REMARKS

Reconsideration and allowance of the above referenced application are respectfully requested. After entry of this amendment, claims 1-20 will be pending in the case.

# PB-100 in QFP (44)

Fig 1

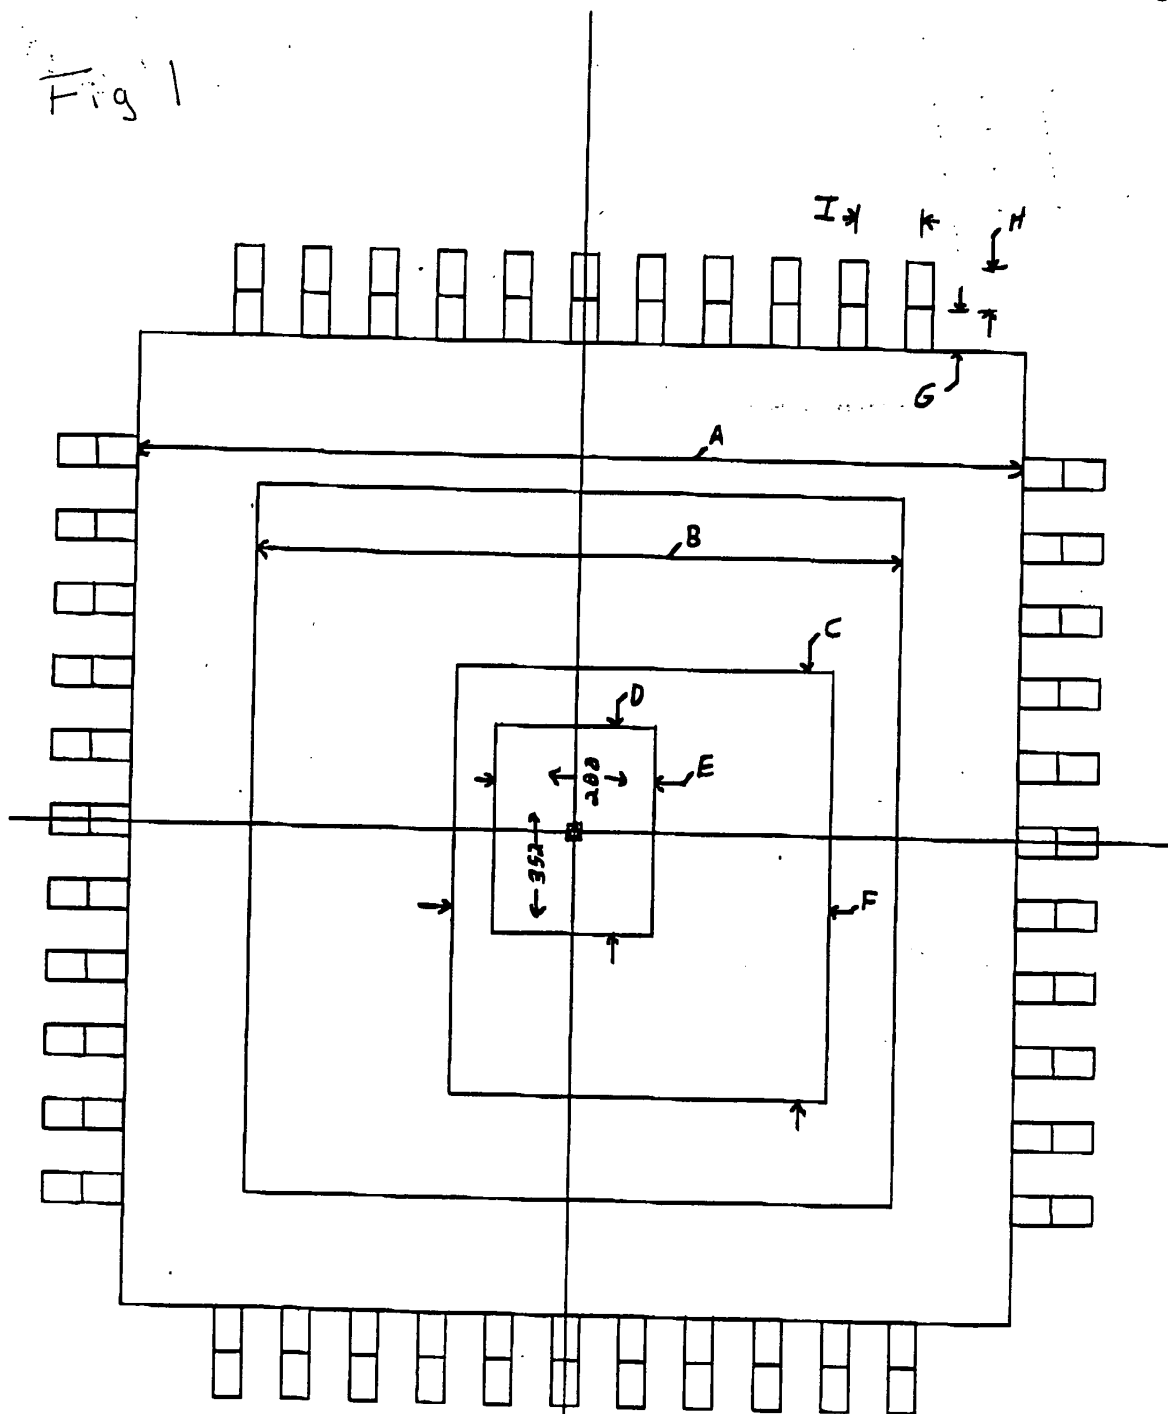
The drawings stand objected to due to informalities. In response, figures 1 and 2 has been amended to include the missing reference signs. The objections to claim 4 have been obviated by the amendment of the preamble of claim 4. The antecedent basis objections have also been corrected.

Attachment: Proposed drawing change.
